**M24128S-FCU package mechanical data modifications**

**Silicon identification**

This errata sheet applies to the M24128S-FCU, that is the 128 Kbit serial I<sup>2</sup>C bus EEPROM delivered in WLCSP four balls.

Figure 2. D and E front side view

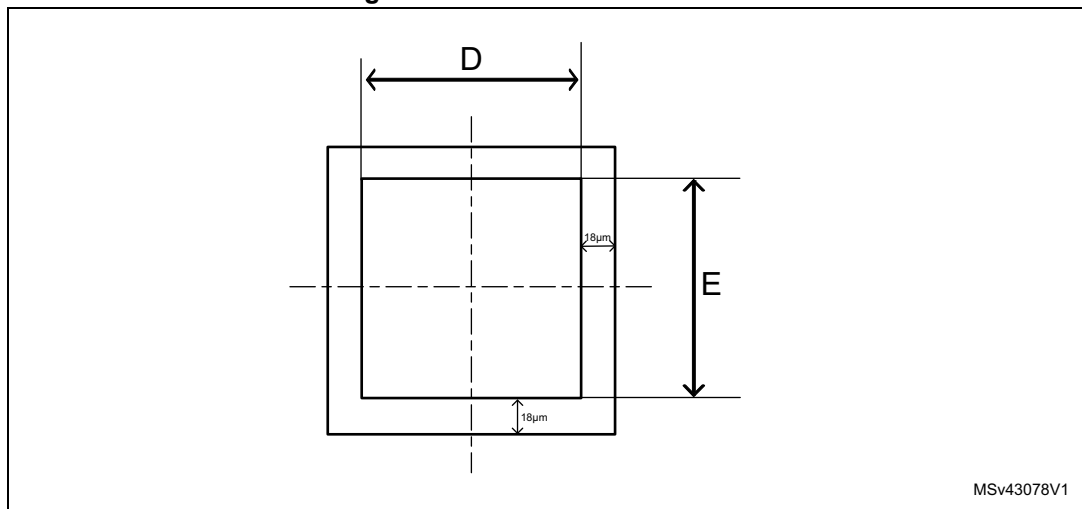
- The D and E values on M24128S-FCU datasheet corresponding to front side view (ball side) as shown in [Table 2](#), instead of back side view (marking side view) as shown in [Table 3](#).

Symbol	Millimeters			Inches		
	Min	Typ	Max	Min	Typ	Max
D	-	0.833	0.853	-	0.0328	0.0336
E	-	0.833	0.853	-	0.0328	0.0336

Figure 3. D and E back side view

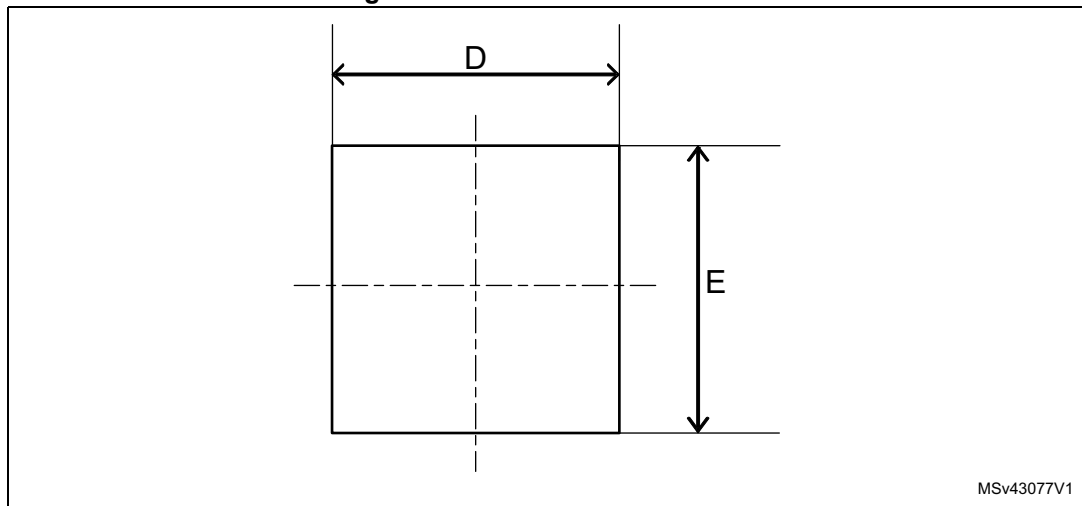
This document refers to the changes of dimensions D and E (see [Figure 3](#)) described in the M24128S-FCU datasheet, in tables detailing the dimensions of the Ultra Thin WLCSP 4-bump package.

D and E values must be modified to correct the following mistake:

Symbol	Millimeters			Inches		
	Min	Typ	Max	Min	Typ	Max
D	0.831	0.851	0.871	0.0327	0.0335	0.0343
E	0.831	0.851	0.871	0.0327	0.0335	0.0343

Figure 4. D or E side view

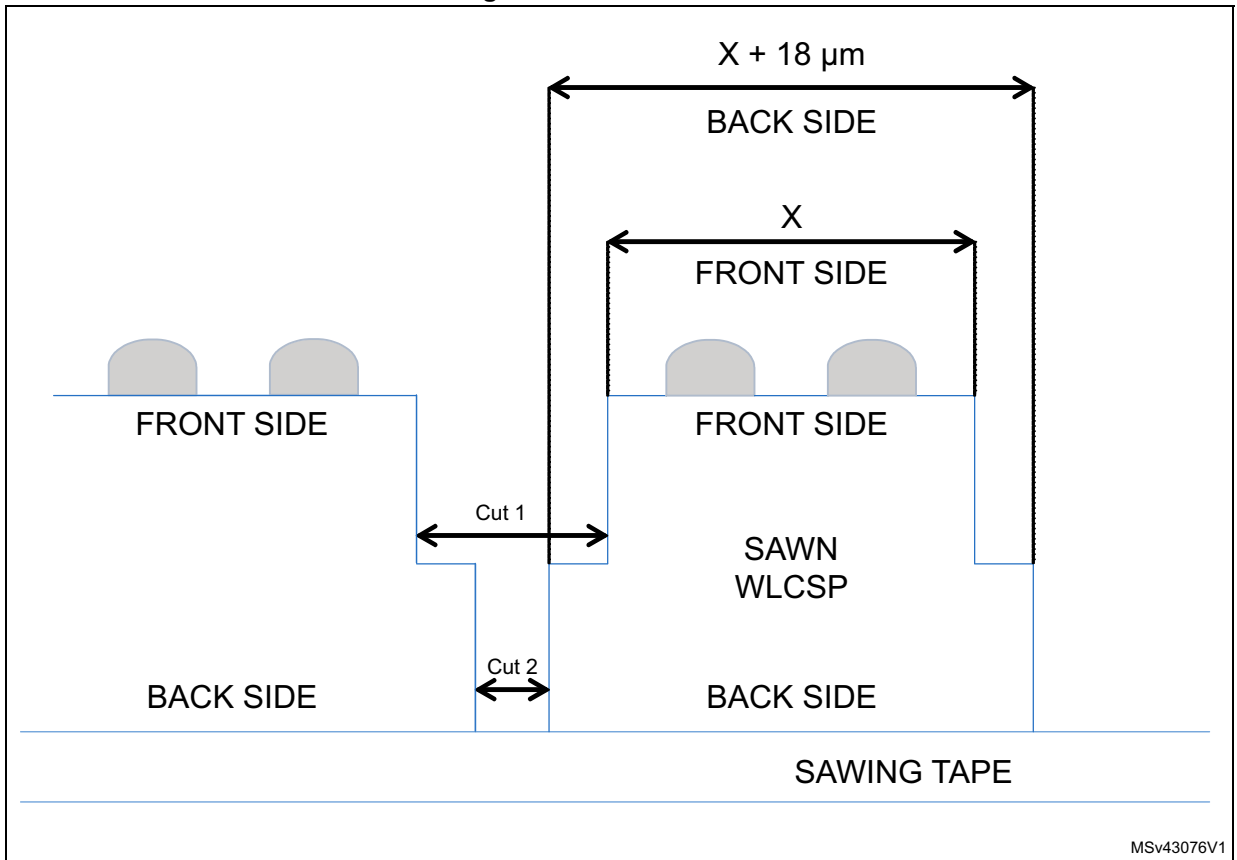
The difference between back side and front side dimension is 18 µm (0.018 mm). This difference is due to two-step sawing process, where cut 1 and cut 2 are performed with blades having different thickness (see [Figure 4](#) in which X represents D or E and it has the same value and tolerance).
